**1429 ECK ROAD OUTDOOR STORAGE**  
**MAJOR PLAN 2022-109**  
**ATTACHMENTS**

**TO: PLANNING COMMISSION**  
**FROM: GREGG R. ADAMS, PLANNER**  
**SUBJECT: 1429 ECK ROAD OUTDOOR STORAGE**  
**MAJOR PLAN 2022-109**  
**REQUEST FOR PRELIMINARY/FINAL PLAN REVIEW**

SUBJECT: South Whitehall Township  
1429 Eck Road Outdoor Storage  
Major Plan #2022-109  
Preliminary/Final Plan Review

**PRELIMINARY/FINAL RECORD PLAN**

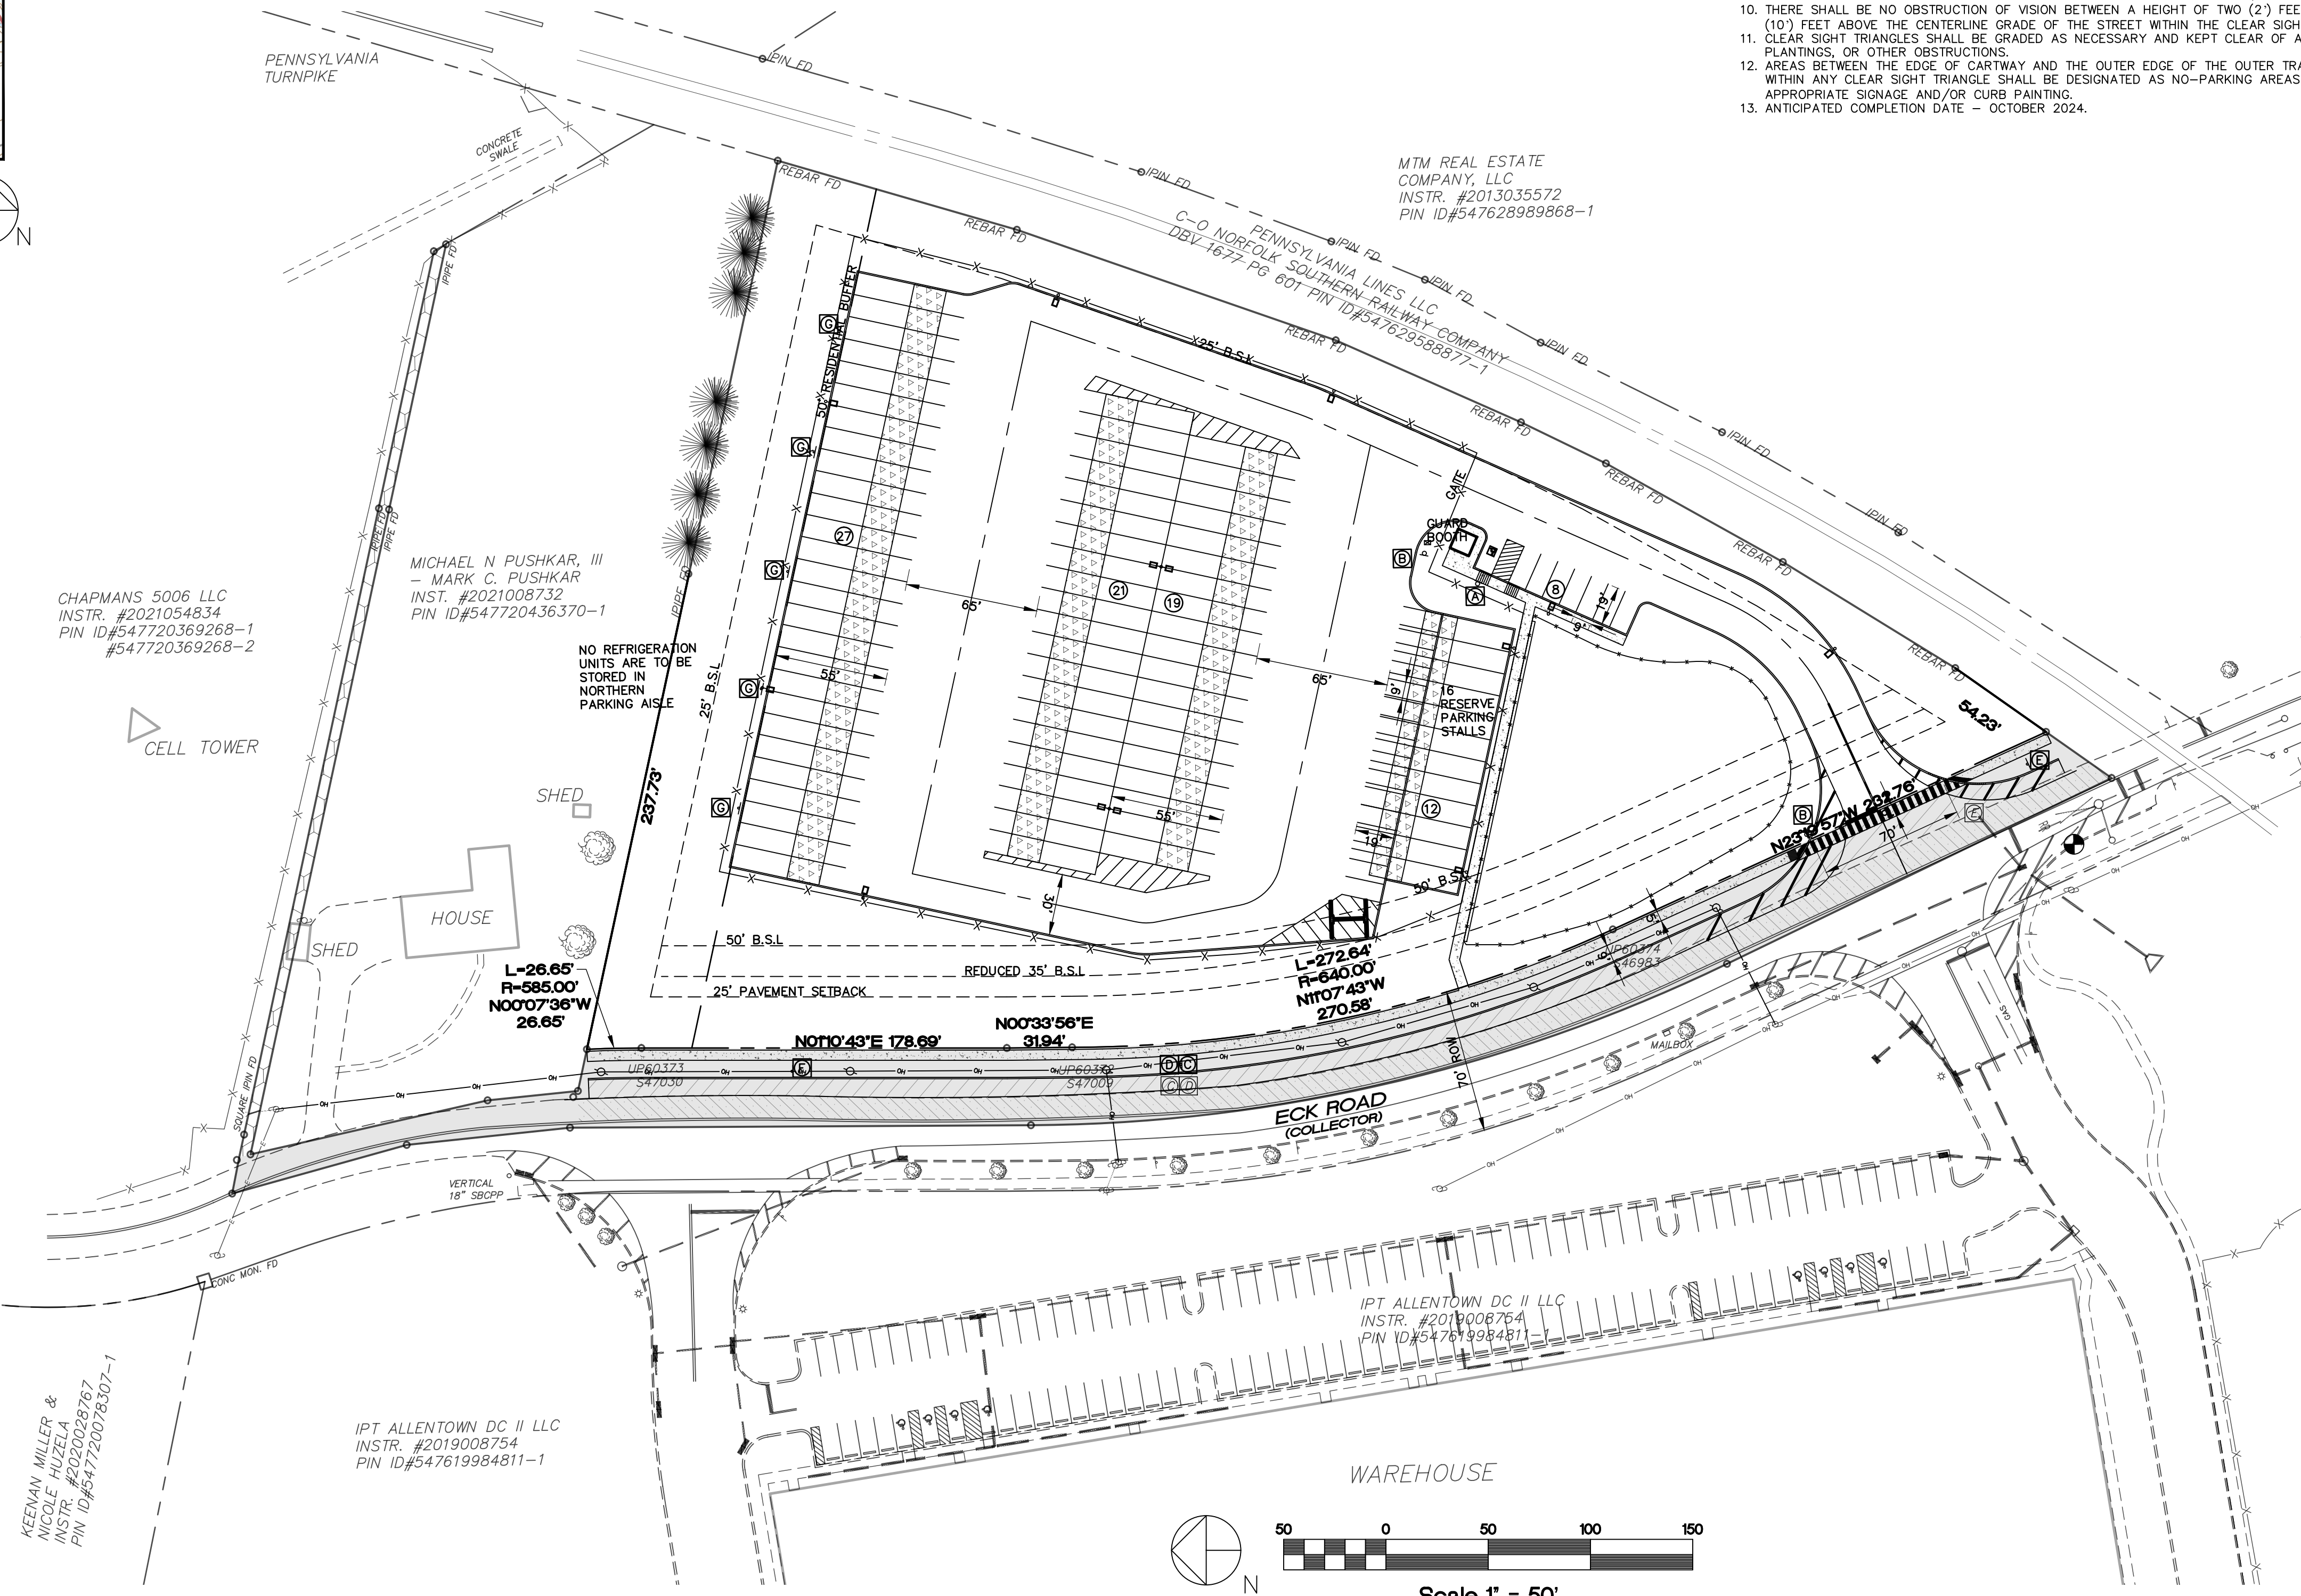
8. Revise the storm sewer pipe run from OCS-1 to ES A-1 to not exceed 400 feet in length, SALDO §312-39(b)(7);
9. Revise the Township Stormwater Management Ordinance reference in Note 9 of the General Development Notes on Sheet 2;

**PRELIMINARY/FINAL LANDSCAPING PLAN**

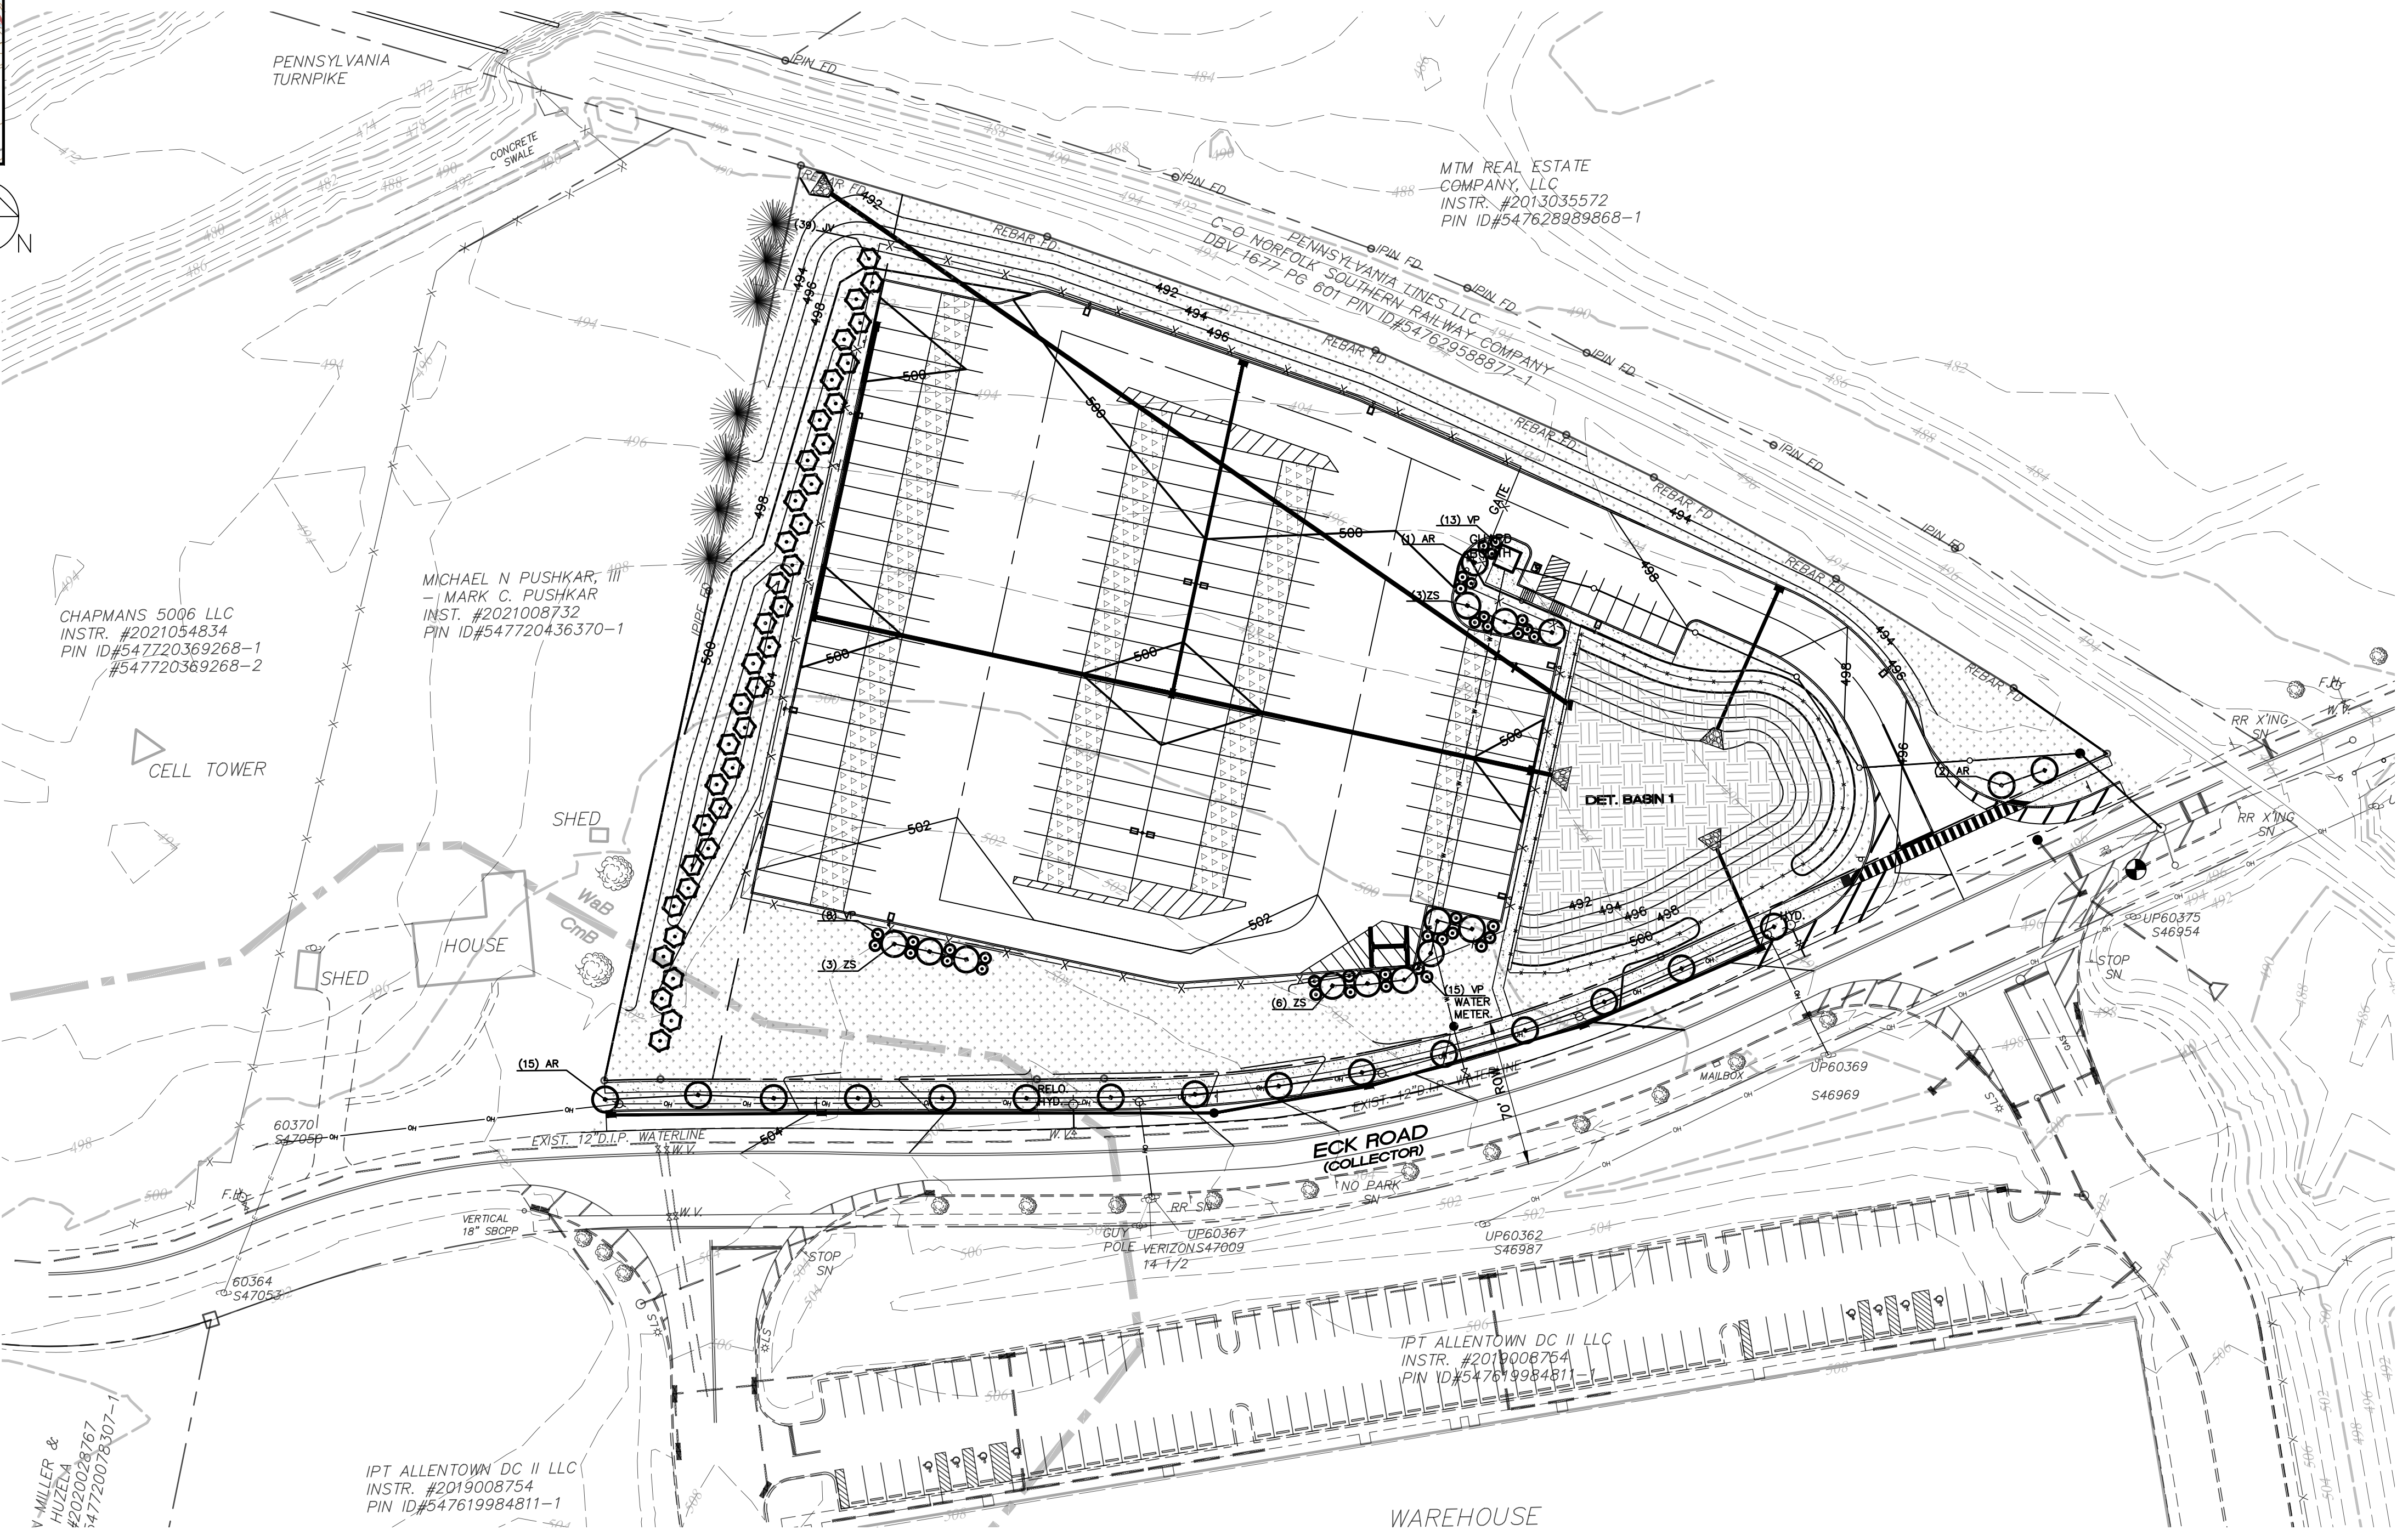
- d. The Commission also noted that the two southernmost street trees are proposed outside of the right-of-way of Eck Road. The Commission recommended that the trees either be moved to within the right-of-way of Eck Road or be placed within a Shade Tree Easement.
2. The plan is scheduled to be reviewed by the Landscape and Shade Tree Commission at their October 23, 2023 meeting.
